MARICOPA COUNTY
Department of Transportation

MEMORANDUM

Subject: Revisions to Sections 336, 321.10.3, 601.2.7 and Detail 200-1

Case 14-12

DETAIL NO.
2200

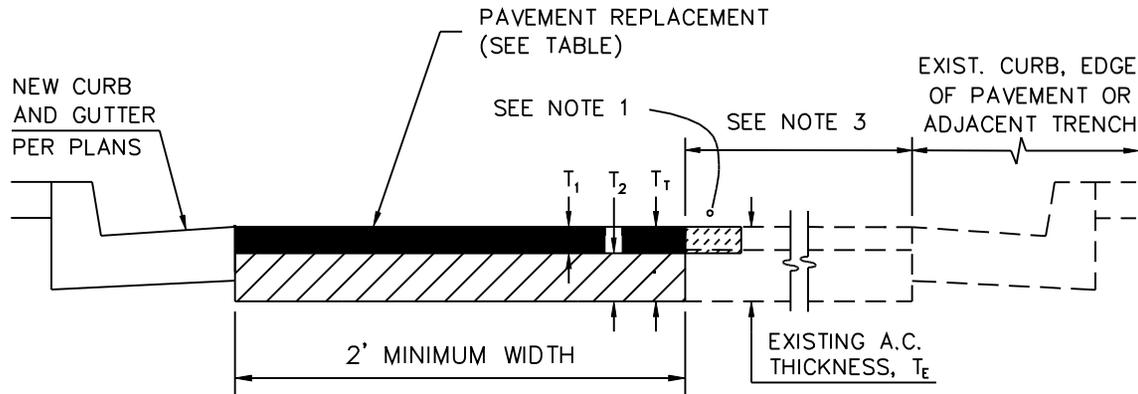
Comment [RTH2]: The asphalt match point shown in Detail 200-1 Type A Trench Repair and the Remnant Pavement Removal detail need to be revised to comply with this paragraph. See Scottsdale Detail 2200 for a suggested staggered joint modification.

Comment [RTH3]: Modify to require staged removal of asphalt pavement for trenches similar to Scottsdale Detail 2200, this provides for re-compaction of the non-confined base course adjacent to the open trench.
